### **PEDAL POWER SUBMISSION**

**DA 2022 41005 DA 2022 41006 DA 2022 41022**  
**Block 21 Section 6, 2 Matilda St Phillip**

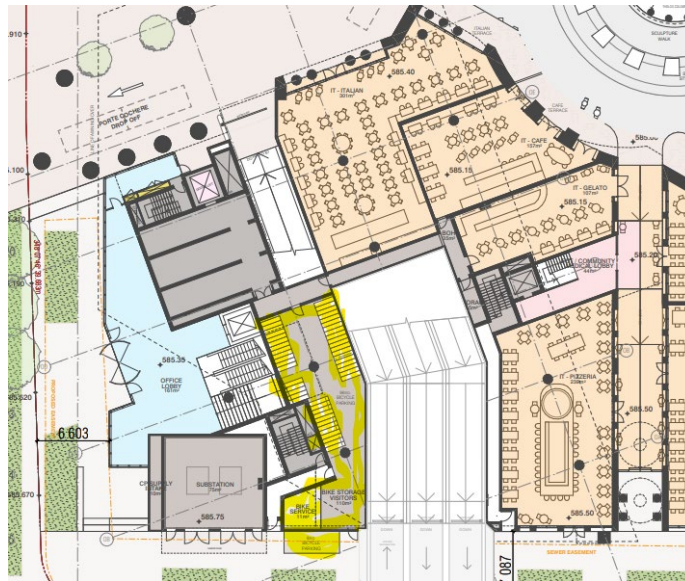
The report then suggests a reduction in need for bicycle parking based on the report's temporal activity profiles. It considers 139 spaces would be reasonable for weekday daytime visitors and 111 spaces for weekend daytime visitors.

Taking all this into account, Pedal Power asks for the Code's provision rates to be applied.

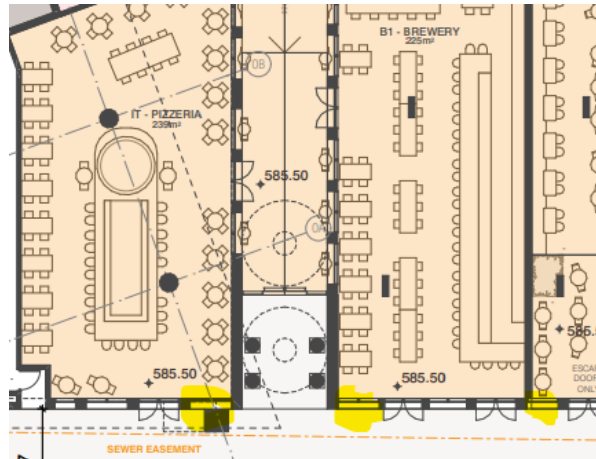
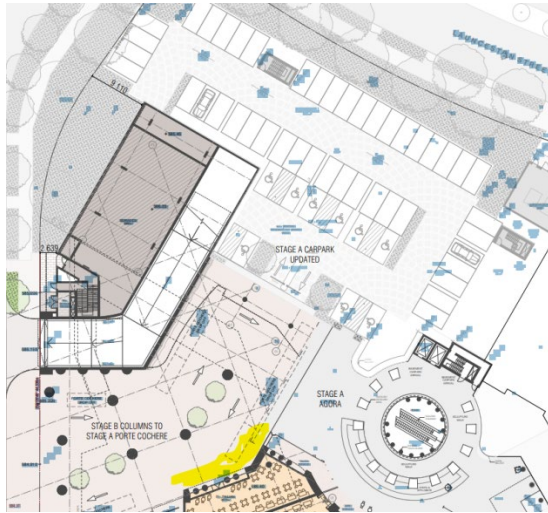
The proposed location of access to the bicycle parking appears problematic.

The ground floor plan seems to suggest the visitor parking entrance is off Matilda St.

It is unclear whether once parked, people can easily gain access to the Club's facilities. If there is no direct access from the inside end of the bike parking area to the Club, people will simply not use it. The on-street bike parking is far away from any of the Club facilities and is unlikely to be used at all.

The plan does not show any bike parking inside the porte cochere area. One of the usual advantages of, and incentives to ride is the ability to travel much closer to one's destination – the door to door advantage of cycling.

Pedal Power asks for bike parking as highlighted below, adjacent to the Italian restaurant and terrace and undercover on Matilda St, to give ready access to the pizzeria, agora, brewery and bistro. This reinforces the need to retain the bikeway on the northern side of Matilda (discussed elsewhere in this submission).
